**OHIO TURNPIKE AND
INFRASTRUCTURE COMMISSION**

ADDENDUM NO. 1

PROJECT NO. 43-19-07

BRIDGE REHABILITATION AND 3RD LANE WIDENING
OHIO TURNPIKE OVER AI CREEK M.P. 47.4,
OHIO TURNPIKE OVER S.R. 64 (N. MAIN ST.) M.P. 47.5
MILEPOST 46.50 TO MILEPOST 50.92
FULTON AND LUCAS COUNTIES, OHIO

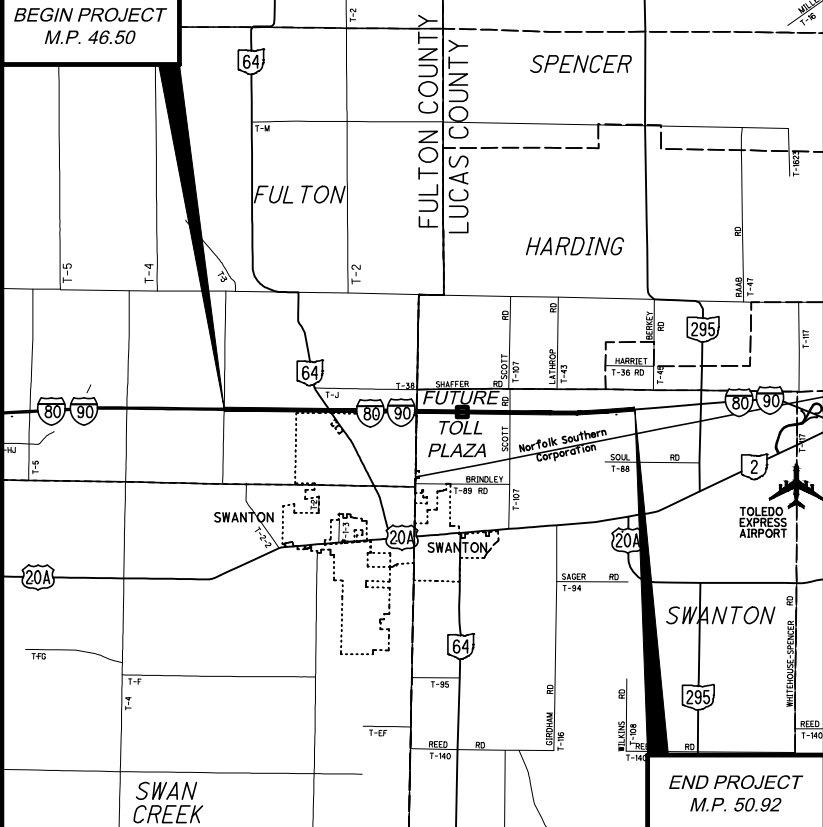
Q#6 Plan sheets do not include OTIC standard drawing CB-1 for the #1 CB bid item (reference 91). Please provide the most updated drawing for this item.

A#6 This Addendum No. 1 revises the OHIO TURNPIKE AND INFRASTRUCTURE STANDARD DRAWINGS list on Plan Sheet 1 of 349 and adds CB-1 dated 10/20/17. No quantity revisions are required as a result of this revision. Revised Plan Sheet 1 of 349 is included as part of this Addendum No. 1.

MAINTENANCE OF TRAFFIC
GENERAL SUMMARY

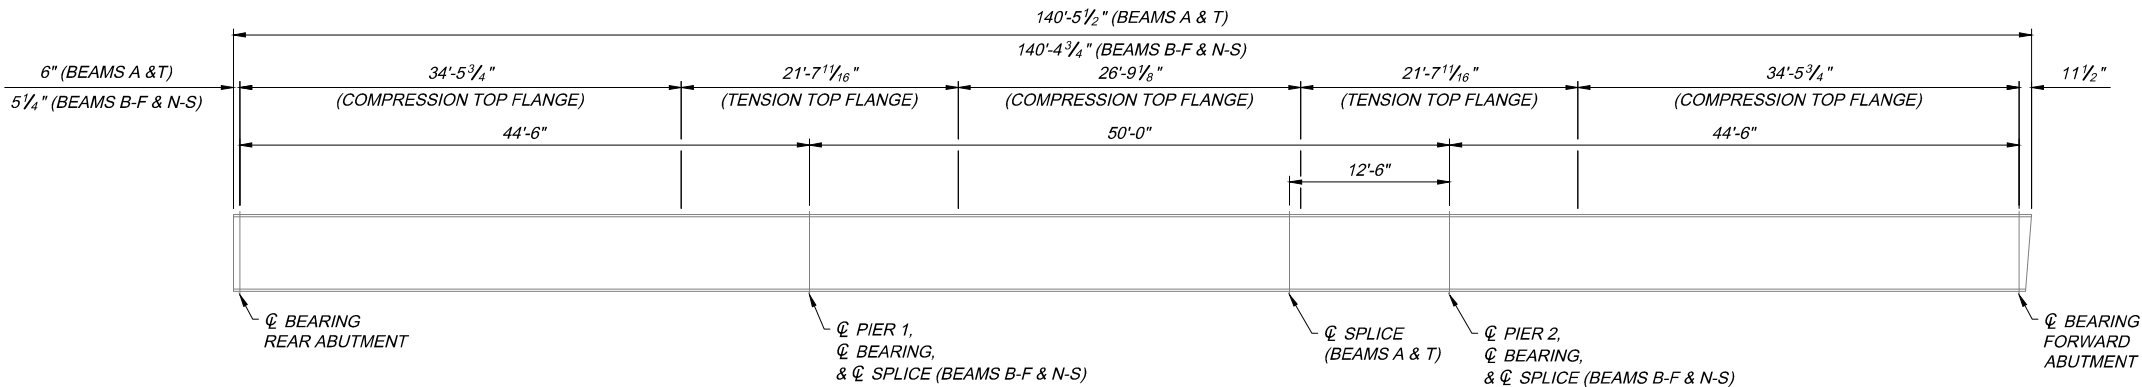
Q#4 Bid items 10 and 120 are both "Pavement Removed, As Per Plan". General summary on sheet 109 calls out bid item 10 with the as per plan note on sheet 15/349. The maintenance of traffic summary on sheet 38 for bid item 120 does not reference an "As Per Plan" sheet. Please provide the "As Per Plan" information for bid item 120.

A#4 This Addendum No. 1 revises the PAVEMENT REMOVED, AS PER PLAN item on Plan Sheet 38 of 349. No quantity revisions are required as a result of this revision. Revised Plan Sheet 38 of 349 is included as part of this Addendum No. 1.

TYPICAL FIELD SPLICE DETAIL

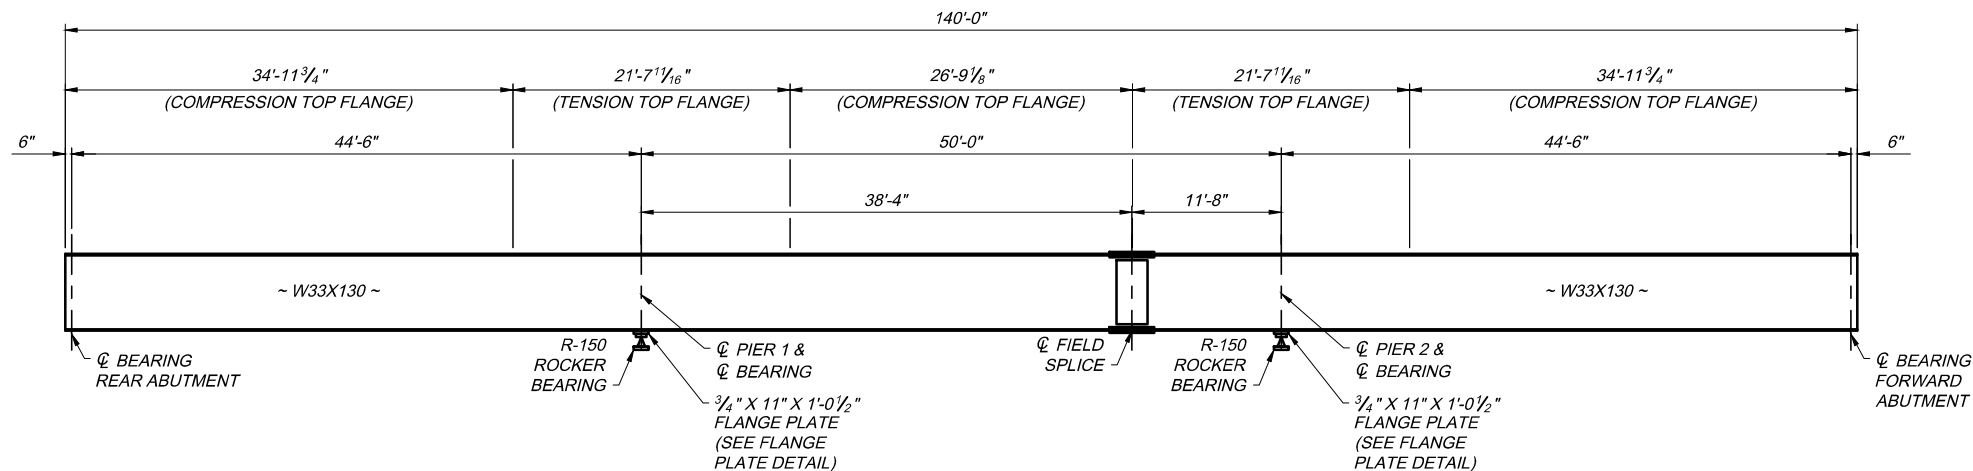
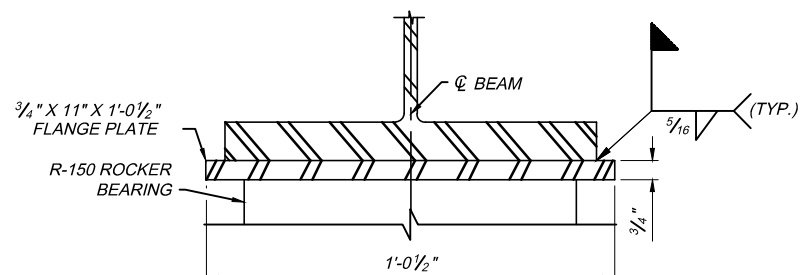
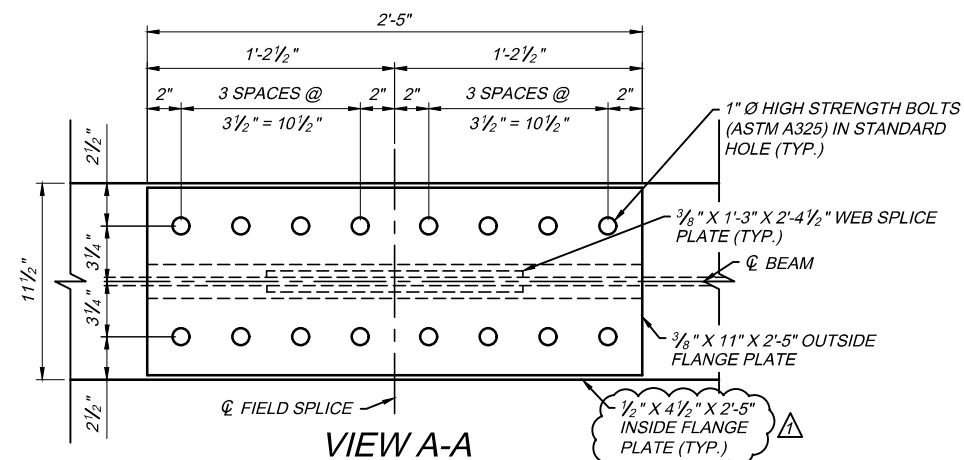
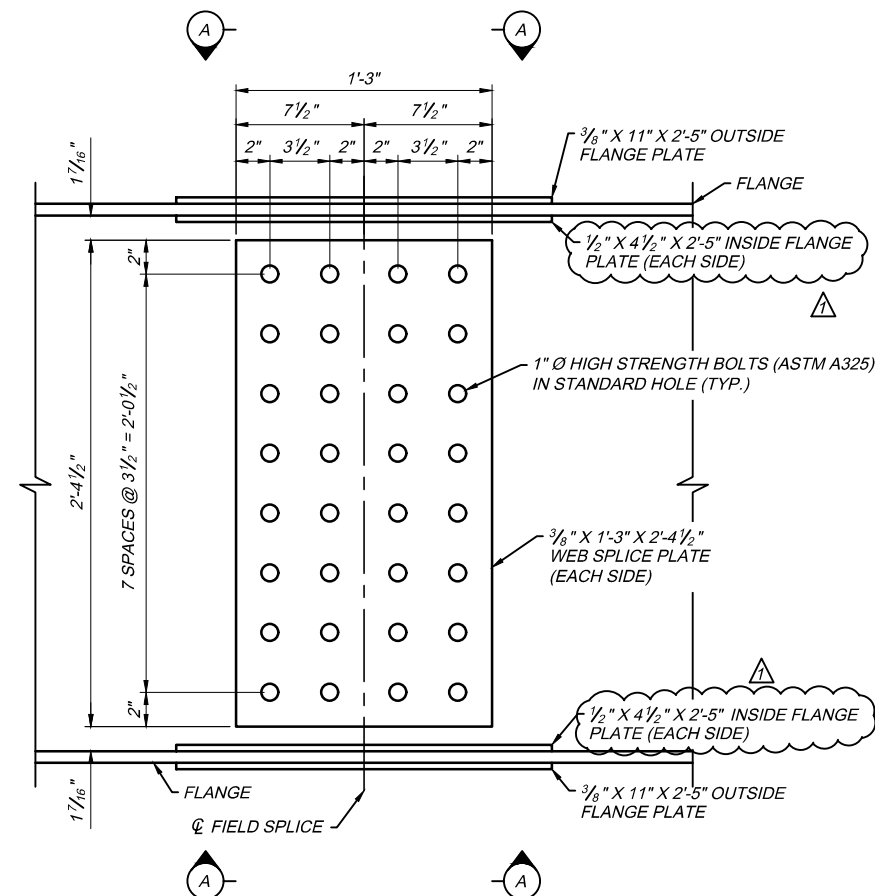
Q#10 A conflict between the splice plate and the flange is apparent. Please review.

A#10 This Addendum No. 1 revises Plan Sheet 309 of 349 to modify the inside flange splice plate callout. No quantity revisions are required as a result of this revision. Revised Plan Sheet 309 of 349 is included as part of this Addendum No. 1.
